CHANCE
MANUFACTURING CO., INC.

Service Information

Ride: ZIPPER

Subject: SEAT SAFETY LUG BOLT CHECK

IMPROPER BOLT

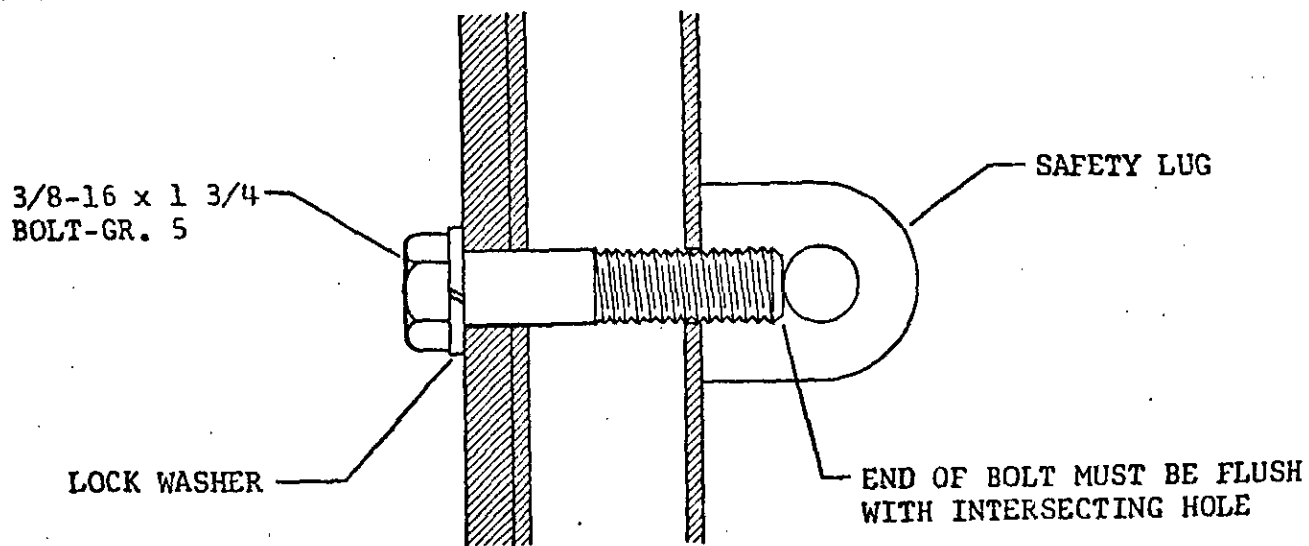
Next, check the grade of the bolt by using the identifying marks on the bolt head.

If the bolt has at least 3 marks on head, it is at least a Grade 5 bolt and is okay.

If the end of the bolt is not visible or is of insufficient grade, it must be replaced.

Remove and discard old bolt. Inspect threads in Safety Lug. If threads appear to be stripping or rounding off, replace the lug and bolt. If threads are okay, replace the bolt. The proper bolt should be a 3/8-16 x 1 3/4 inch long bolt of at least a Grade 5.

Do not substitute ordinary hardware store bolts, as these are usually only about a Grade 3.

FIGURE A

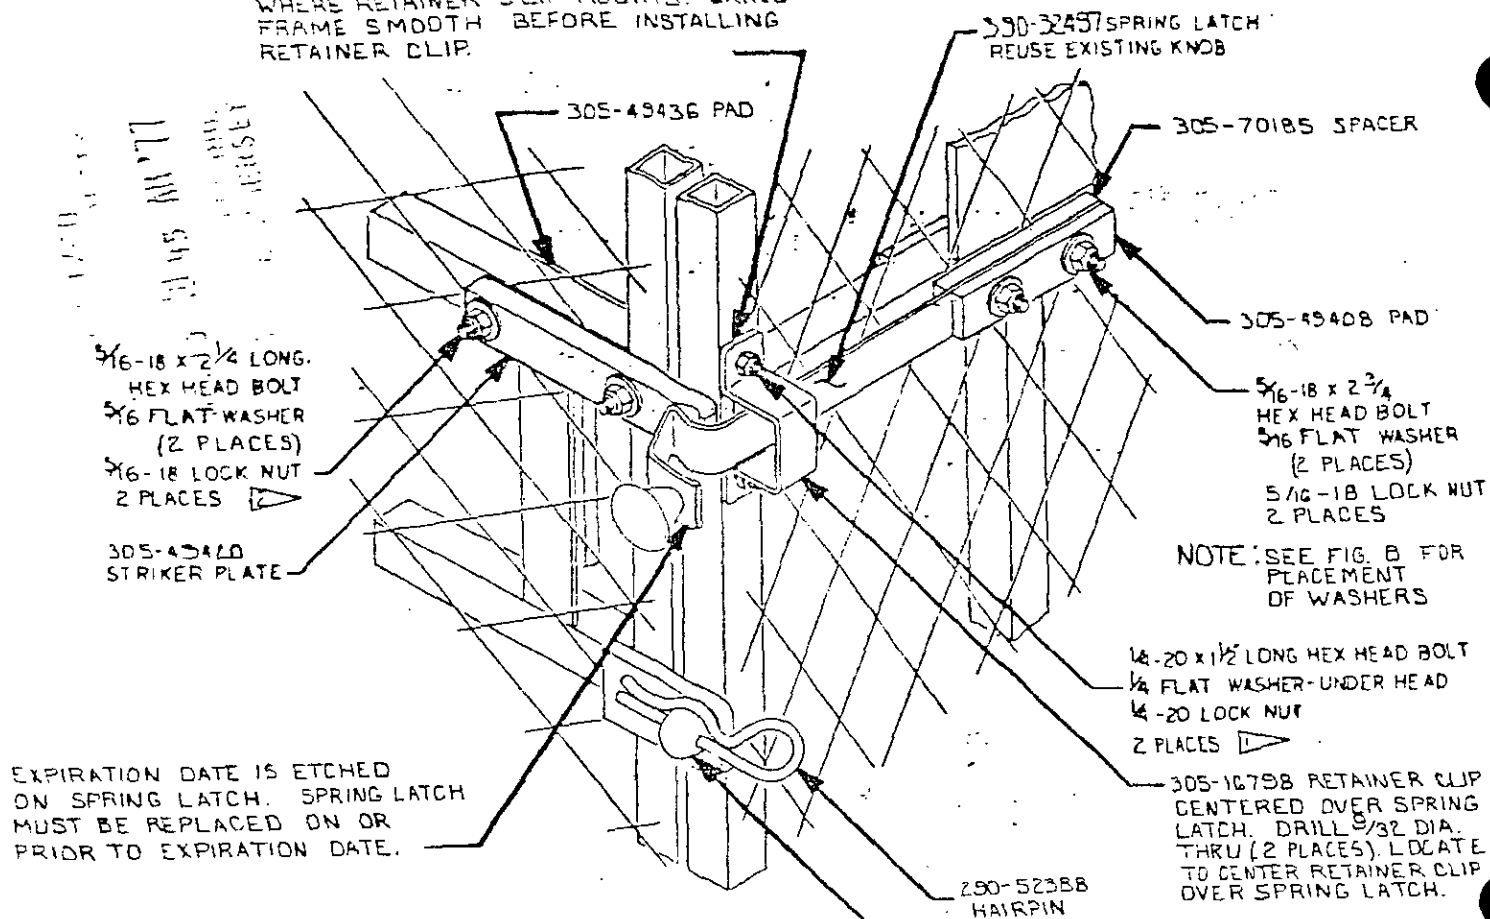
REMOVE EXPANDED METAL FROM FRAME WHERE RETAINER CLIP MOUNTS. GRIND FRAME SMOOTH BEFORE INSTALLING RETAINER CLIP.

Install the 305-49420 Stricker Plate and 305-49436 Pad on the door. Position the Stricker Plate as shown in figure B. Torque attaching bolts to 15 ft. lbs.

1 Torque to 7 ft. lbs.

2 Torque to 15 ft. lbs.

3 Torque to 27 ft. lbs.

FIGURE B

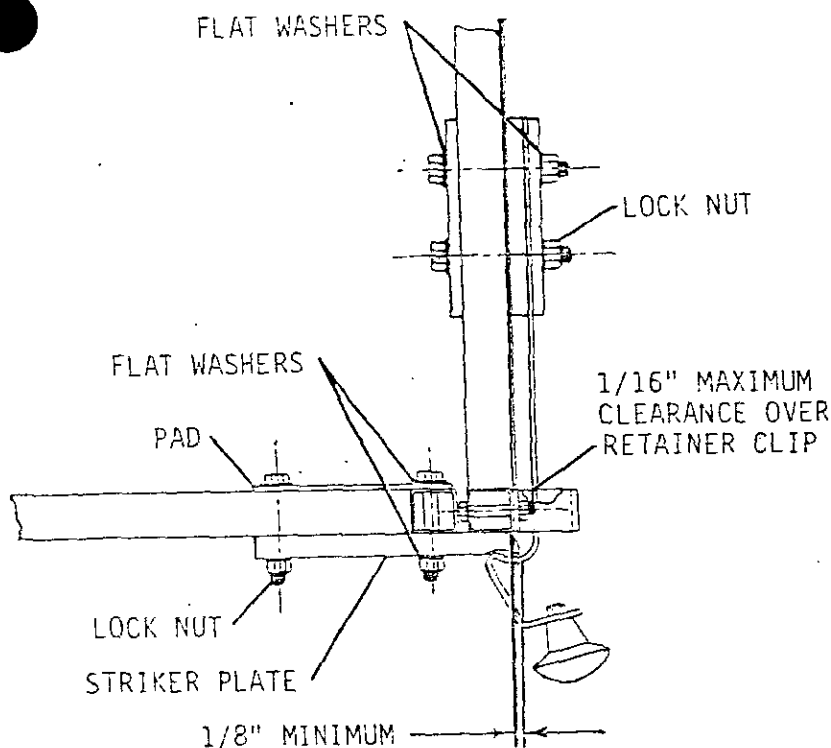
The 390-32497 Spring Latch on each seat must be checked daily. The Spring Latch must be centered on the 305-49420 Striker Plate and should clear the base of the 305-16798 Retainer Clip no more than $1/16$ " as shown in figure B thus insuring adequate overlap of Spring Latch and Striker Plate and preventing the door from opening unless released by pulling on Spring Latch knob. Spring Latches which clear the base of the Retainer Clip more than $1/16$ should be replaced immediately and the seat not used until this has been done. (FIGURE B) Do not attempt to straighten or repair the Spring Latch in any way. Each Spring Latch must be replaced on or before the expiration date (month and year) etched at the knob end.

When installed, the striker plate should extend a minimum of 1/8" beyond the edge of the frame.

FIGURE A

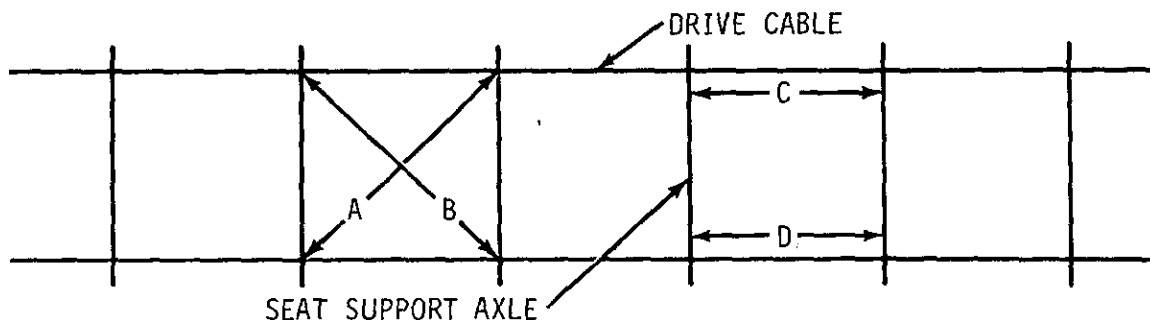
Check the alignment of the seat support axles to see that they are square with one another. Measure and record the distance diagonally both directions (dimensions A and B) between common points on all of the seat support axles. (See Figure A) Measure and record the distance between all of the axles at common points parallel to the drive cables (dimensions C and D). If the C or D dimensions are not consistent, loosen the necessary U-bolt and move the seat support axle as required. Measurements and adjustments must be performed while the seat support axles are at a straight section of track and all of the cross cables have been removed.

If one of the drive cables has slipped the A dimensions will differ from the B dimensions, but the C and D dimensions will be the same. To correct this, install one cross rod at dimension A or B which ever is the longest (See Figure B) and tighten the cross rod. "Jog" the drive cables by running the cable drive first one direction and then the other for a few inches. Tighten the cross rod and repeat procedure until the A and B dimensions are the same.

If one drive cable has stretched more than the other the C dimensions (See Figure A) differ from the D dimensions, but the A and B dimensions will be the same. This can be corrected by adjusting the sheave drive axles so that the shorter drive cable will stretch to the same length as the longer one.

FIGURE C

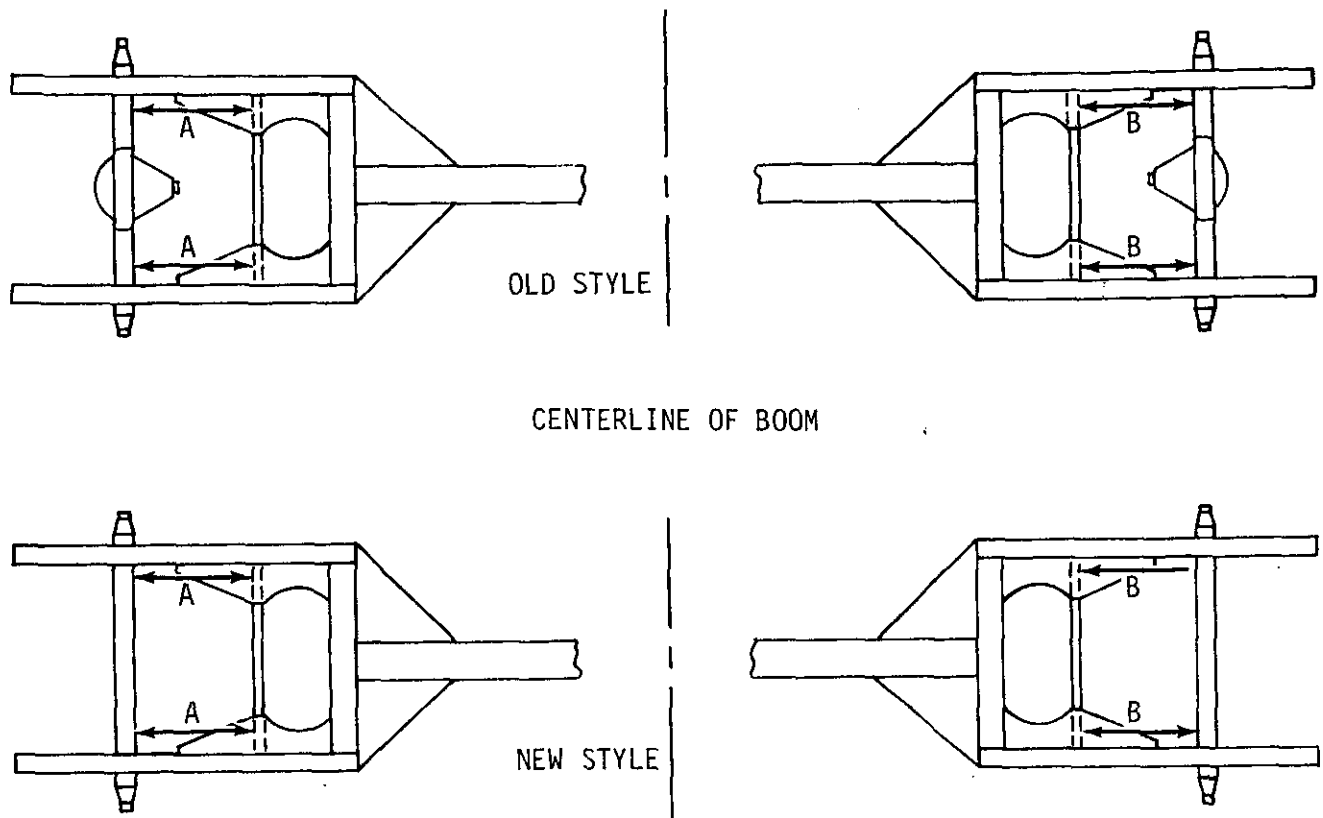
Before adjusting the drive cables, check both sheave drive axles for alignment. Check each axle by measuring from a common point on the differential axle (old models) or the solid shaft axle (new models) to the first cross channel on the boom. (Fig. C) The two dimensions must be the same on both sides of the same axle. Then compare the dimensions from both axles. There must be no more than one inch difference between the two axles.

BOTH A DIMENSIONS MUST BE THE SAME
 BOTH B DIMENSIONS MUST BE THE SAME
 THERE MUST BE NO MORE THAN ONE INCH DIFFERENCE
 BETWEEN THE A AND B DIMENSIONS

FIGURE A

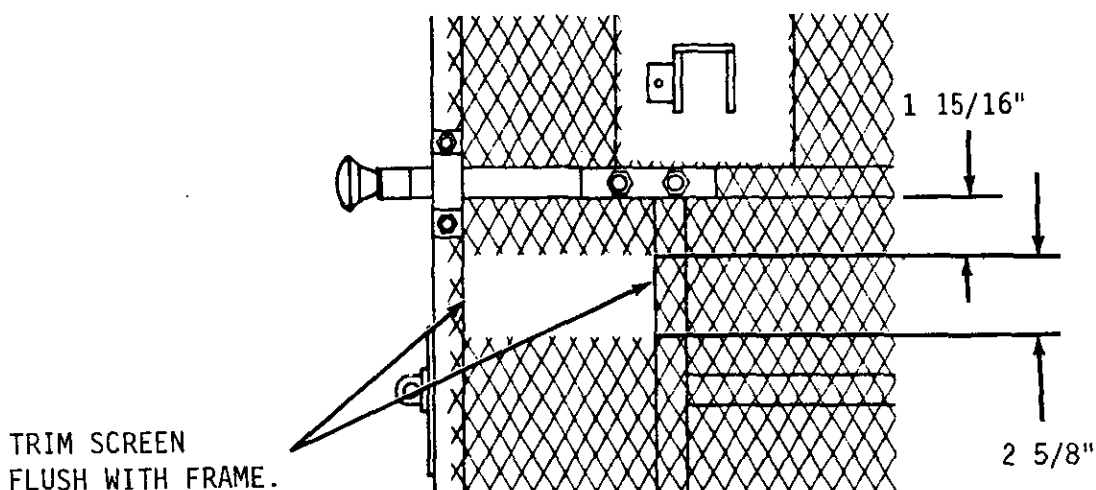
Remove screening from area shown in FIGURE A.

FIGURE B

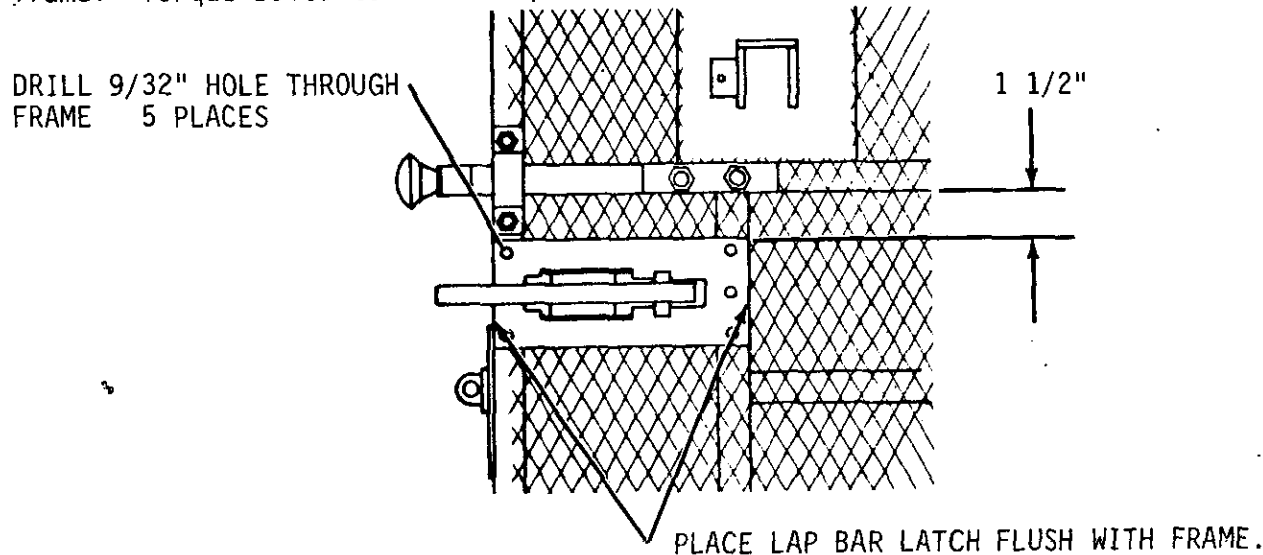
Place the 305-39677 Lap Bar Latch in position as shown in FIGURE B. Use Lap Bar Latch as a pattern and drill the attaching holes through frame in 5 places using a 9/32\"

Attach Lap Bar Latch to frame with 1/4-20 X 1 3/4\" bolts and lock nuts. Insert bolts with 1/4\" flat washers under head and with nuts on the outside of the frame. Torque bolts to 72 inch pounds.

Both right and left hand Lap Bar Latch included in this kit. Install Lap Bar Latch so that the heads of the Socket Head Shoulder Bolt and the Clevis Pin are on the top side of the Lap Bar Latch.

FIGURE C

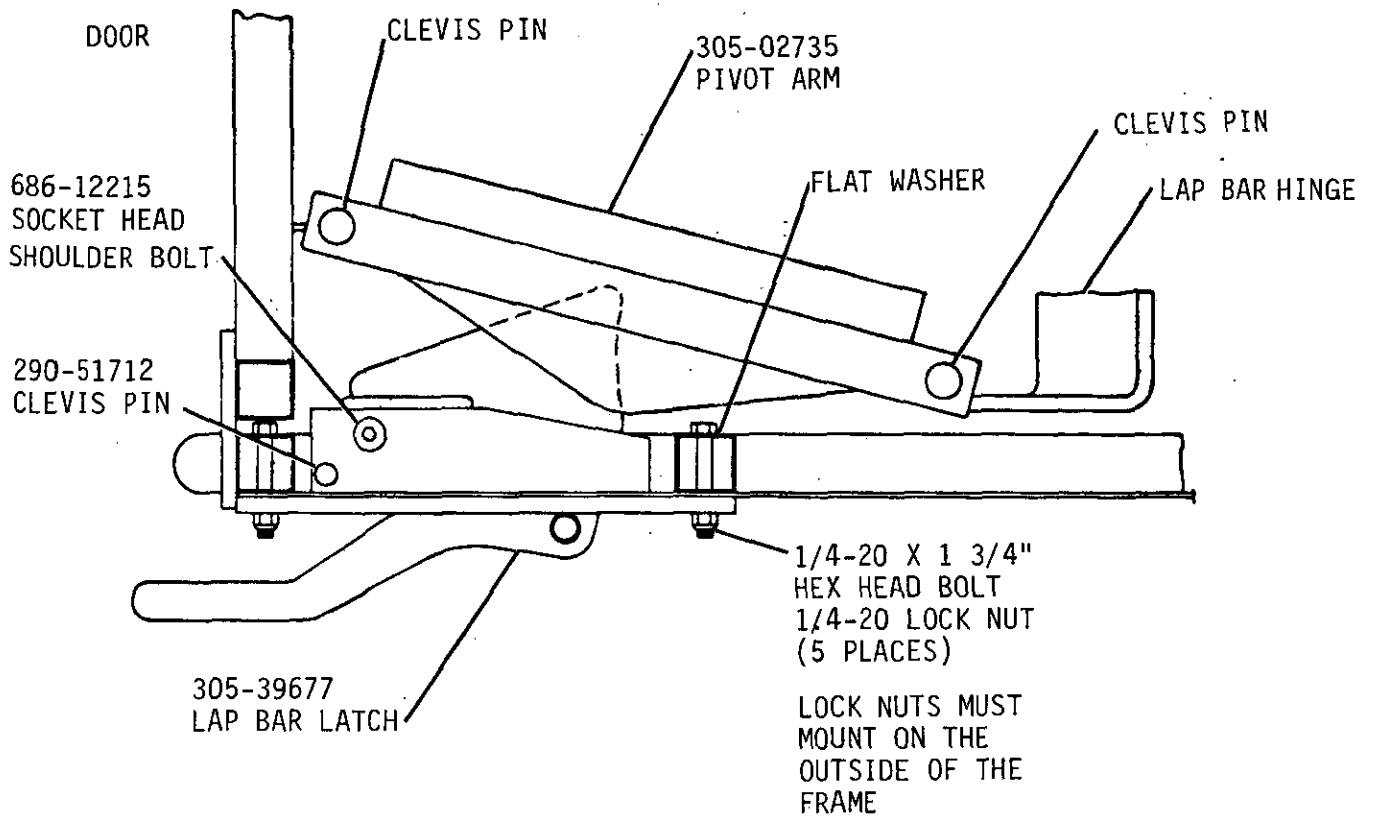
DOOR SHOWN IN THE
CLOSED POSITION

Lap Bar Latch must overlap Lap Bar Hinge a minimum of 1/2".

FIGURE F

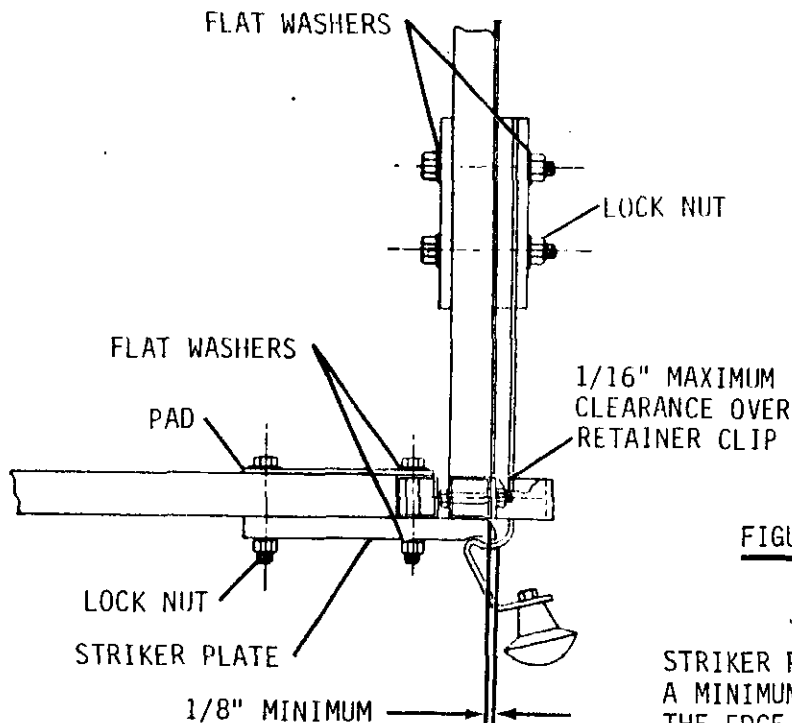
The 390-32497 Spring Latch must be centered on the 305-49420 Striker Plate and should clear the base of the 305-16798 Retainer Clip no more than 1/16" as shown in Figure F, thus insuring adequate overlap of Spring Latch and Striker Plate and preventing the door from opening unless released by pulling on Spring Latch knob. Spring Latches which clear the base of the Retainer Clip more than 1/16" should be replaced immediately and the seat not used until this has been done. (FIGURE F). Do not attempt to straighten or repair the Spring Latch in any way. Each Spring Latch must be replaced on or before the expiration date (month and year) etched at the knob end. Attaching bolts must be retorqued if found loose.

STRIKER PLATE MUST EXTEND
A MINIMUM OF 1/8" BEYOND
THE EDGE OF THE FRAME.

FIGURE A

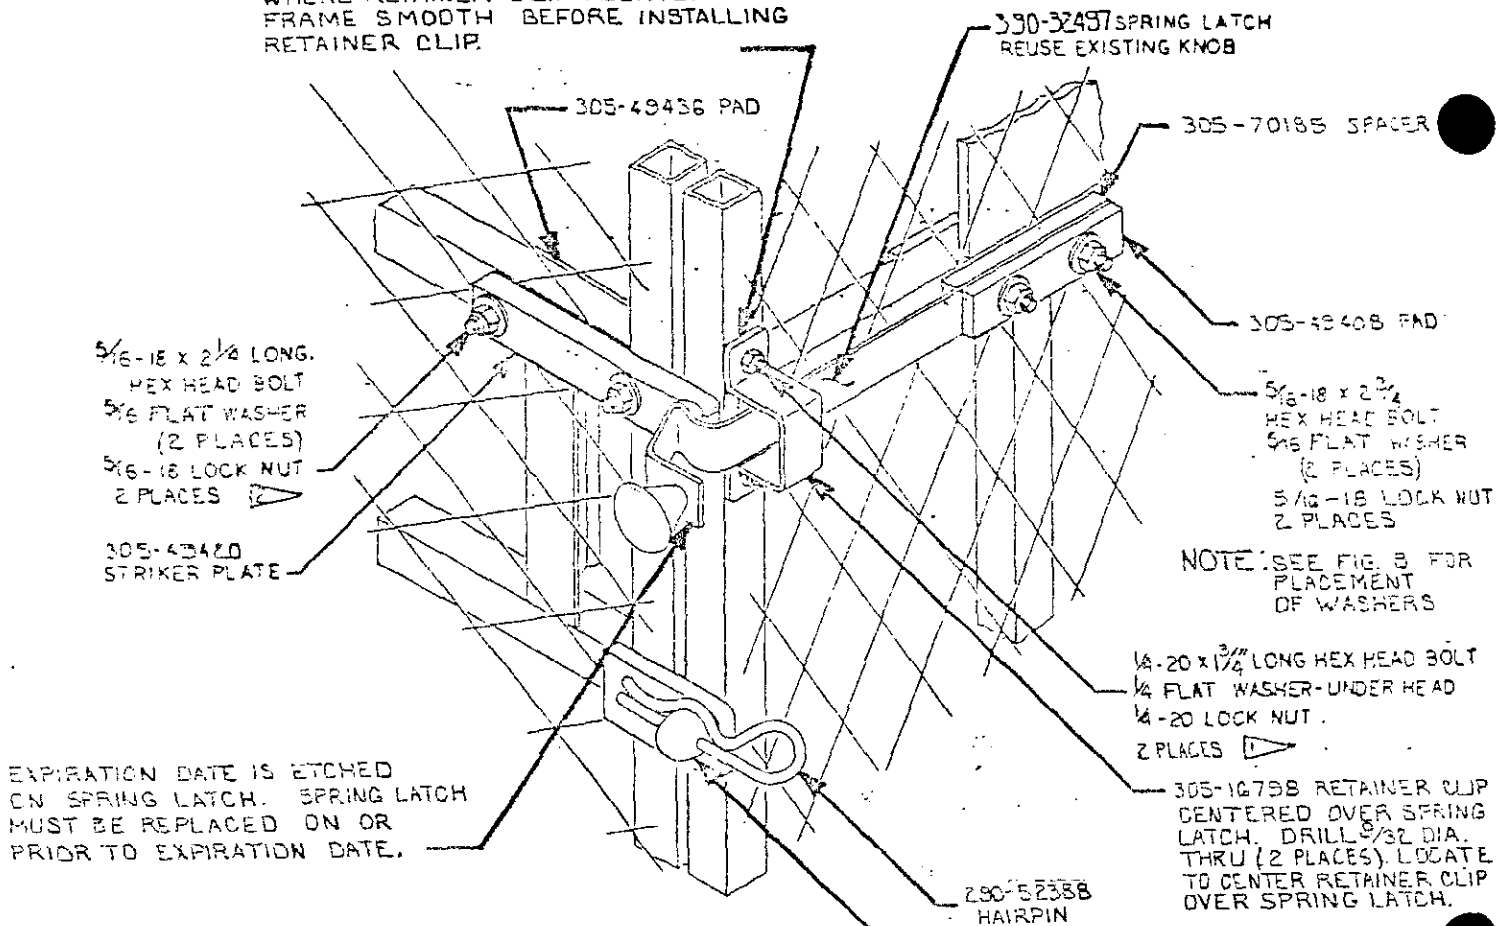
REMOVE EXPANDED METAL FROM FRAME WHERE RETAINER CLIP MOUNTS. GRIND FRAME SMOOTH BEFORE INSTALLING RETAINER CLIP.

Install the 305-49420 Stricker Plate and 305-49436 Pad on the door. Position the Stricker Plate as shown in figure B. Torque attaching bolts to 15 ft. lbs.

NOTE: SEE "SAFETY KNOB INSTALLATION" FOR CORRECT LENGTH OF CAP SCREW TO USE WITH SAFETY KNOB.

FIGURE A

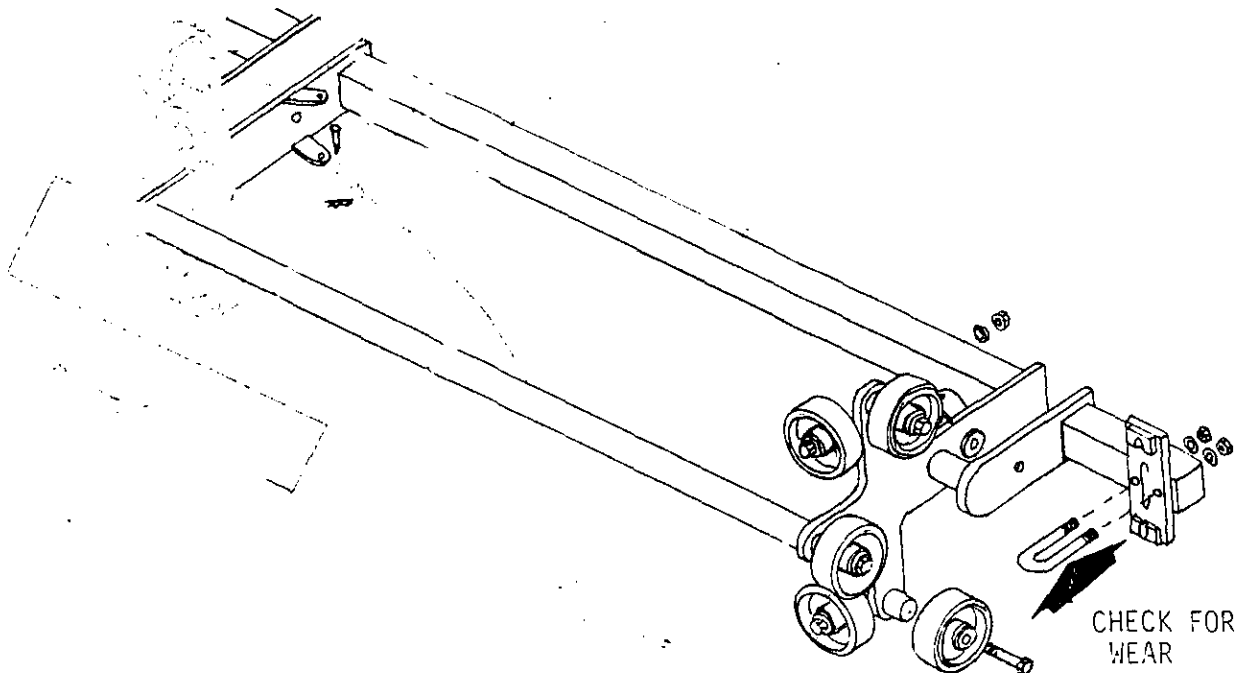
As a safety precaution, all Zipper owners are being asked to inspect all cable clamp "U" bolts (See Figure A).

This condition could result in extensive wear both externally and at the cable clamping surface.

Please inspect all clamps for signs of wear and notify Chance Manufacturing if such a condition exists.
